TRUCK UTILITY LIGHTWEIGHT MC2 - LANDROVER SERIES 3 - ALL TYPES
FRONT BUMPER BAR MOUNTING

MODIFICATION INSTRUCTION

1. This instruction details the action required to overcome problems of weld failure and cracking occurring in the front bumper bar mounting brackets.

FIG 1 - LH BUMPER BAR MOUNTING BRACKET

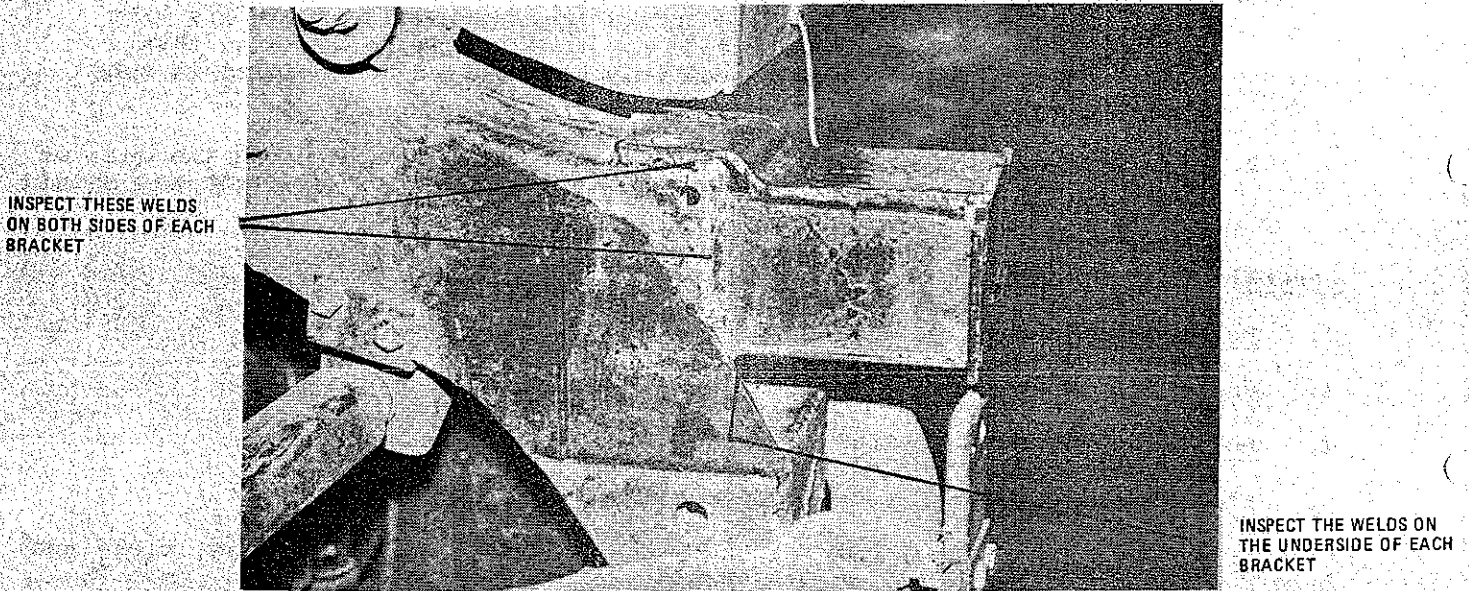
7. To carry out the modification proceed as follows:
- Disconnect the vehicle battery and the wiring from the rear of the alternator. On FFR vehicles, disconnect the radio batteries, vehicle alternator and 28 volt generator wiring. Remove all communications equipment from the vehicle.
 - Remove the front bumper bar assembly from the vehicle.
 - Clean and inspect the condition of all welds securing the bumper bar mounting brackets to the L and RH chassis rails as shown in Fig 1.
 - Clean and inspect the bumper bar mounting bracket flanges (Fig 2) for signs of cracking.

FIG 3 - BOLTS FITTED TO RE-DRILLED HOLES IN END OF
RH CHASSIS RAIL

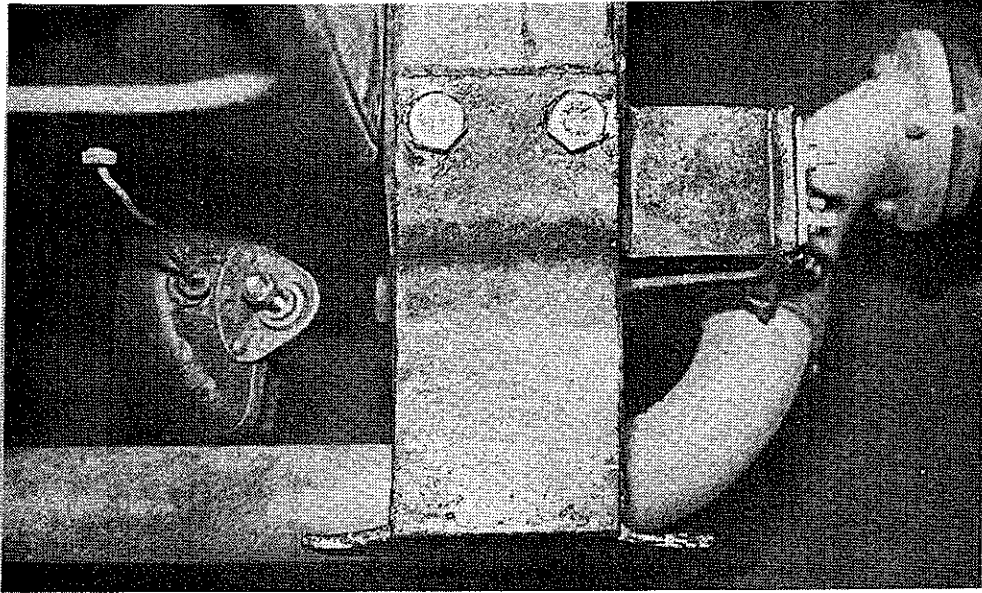
- e. Where the condition of any weld is in doubt or where cracking has been identified, repair by re-welding.
- f. All welding repairs are to be carried out in accordance with WKSP B 002-1 employing either Manual Metal Arc Welding (MMAW) and item 1 from Table 1 or Gas Metal Arc Welding (GMAW) using items 2 and 3 from Table 1.
- g. Re-drill the existing two holes in the ends of each chassis rail as shown in Fig 2 to 1/2 inch diameter.
- h. Fit item 4 from Table 1 to the holes in the ends of the chassis rails as shown in Fig 3 and secure as shown in Fig 4 using items 5 and 6 from Table 1. Torque to 95Nm (70 ftlbs).

FIG 6 - REINFORCEMENT PLATE CORRECTLY POSITIONED ON THE END OF THE LH BUMPER BAR MOUNTING BRACKET

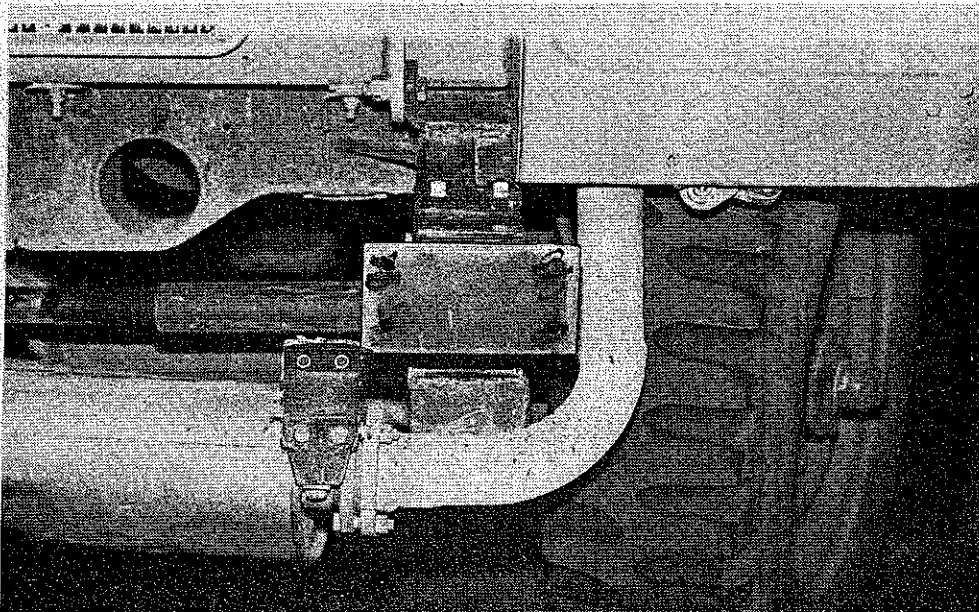
- j. Remove all rust and paint from the face and edges of the mounting bracket flanges.
- k. Position one plate against the end of each mounting bracket as shown in Fig 6. Using either of the methods identified in sub-paragraph 7f, weld all round as shown in Fig 7.

FIG 7 - REINFORCEMENT PLATE WELDED IN POSITION

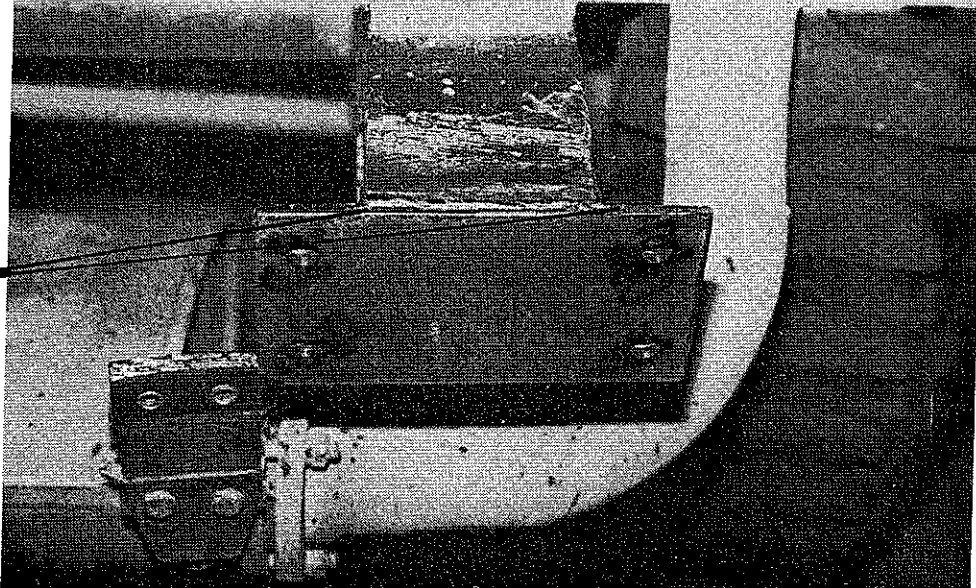
GRIND BACK THIS
WELD TO PERMIT
RE-FITTING OF THE
BUMPER BAR

1. If necessary grind back the top welds as shown in Fig 7 to permit the bumper bar to be refitted.
 1. Paint all reworked areas in accordance with WKSP B 700. Those vehicles whose front air lift brackets are painted with a white horizontal stripe are also to be painted in accordance with WKSP B 700.
 - m. Refit the front bumper bar assembly using items 8, 9 and 10 from Table 1.
 - n. Reconnect all wiring and batteries that were disconnected in sub-paragraph 7a.
8. Modification Record Plate. On completion of the modification deface the numeral 21 on the vehicle modification plate. Enter the details of this modification in Part 3 of the vehicle Record Book for Service Equipment TGM 120.
